Officer Liz Anderson – Ecologist
Date 23/03/2026

Ref: 25/03149/RM
Att: Ben Glover

Land Between Royston Road and Cambridge Road, Barkway

Approval of reserved matters (access, appearance, landscaping, layout and scale) for the erection of 140 residential dwellings with associated landscaping, highways, drainage, public open space and ancillary infrastructure pursuant to outline planning permission reference 25/02234/S73 granted 03.12.2025

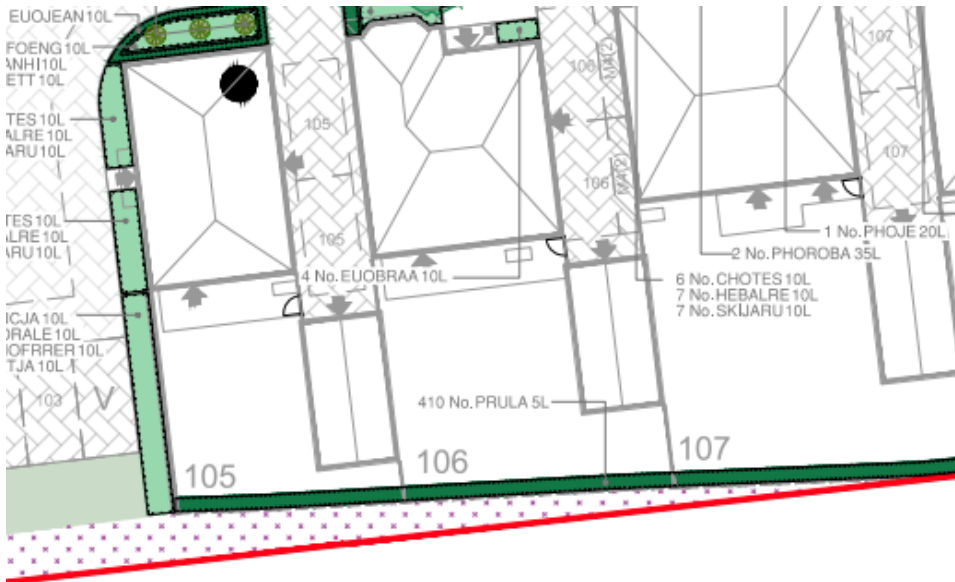
It is noted that Redrow accepts and welcomes the suggested condition to secure an Ecological Enhancement Plan. Wording repeated below for clarity;

Ecological Enhancements

No development shall take place until an Ecological Enhancement Plan (EEP) for the creation of new wildlife features such as the inclusion of integrated bird/bat boxes in buildings/structures and hedgehog highways has been submitted to and approved in writing by the local planning authority. Swift bricks should be used where building heights allow.

Reason: To ensure development is ecologically sensitive and secures biodiversity enhancements in accordance with the National Planning Policy Framework.
